Technical Service Bulletin

SUBJECT:			No: TSB-19-54-015
VEHICLE POSITION ON NAVIGATION SCREEN DISPLAYS AHEAD OF ACTUAL POSITION			DATE: July 2019
			MODEL: 2018-19 Eclipse Cross
CIRCULATE TO:	<input type="checkbox"/> GENERAL MANAGER	<input checked="" type="checkbox"/> PARTS MANAGER	<input checked="" type="checkbox"/> TECHNICIAN
<input checked="" type="checkbox"/> SERVICE ADVISOR	<input checked="" type="checkbox"/> SERVICE MANAGER	<input checked="" type="checkbox"/> WARRANTY PROCESSOR	<input type="checkbox"/> SALES MANAGER

COMBINATION METER REPROGRAMMING CHART

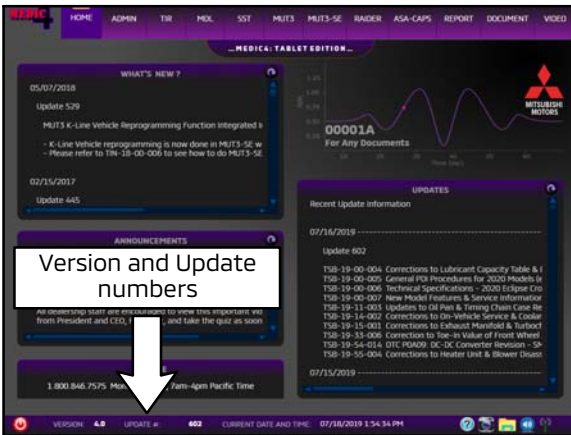
The vehicle position on the navigation screen (MMCS) may incorrectly display the vehicle ahead of the actual position. This may be due to improper combination meter software, where the distance information sent to the navigation system is greater than it actually is. Since the MMCS system uses the vehicle speed pulse signal from the combination meter, the vehicle position displays incorrectly.

This TSB instructs dealers to reprogram the Combination Meter with updated software to correct the vehicle position display issue.

Model	Combination Meter Part Number	Data No.	Software Part Number		Software Version	
			Previous	New	Previous	New
2018 - 2019 Eclipse Cross	8100C421 8100C423	8150A067	1111000000	1111220000	011101	011129
	8100C421 8100C423		1111210000		011119
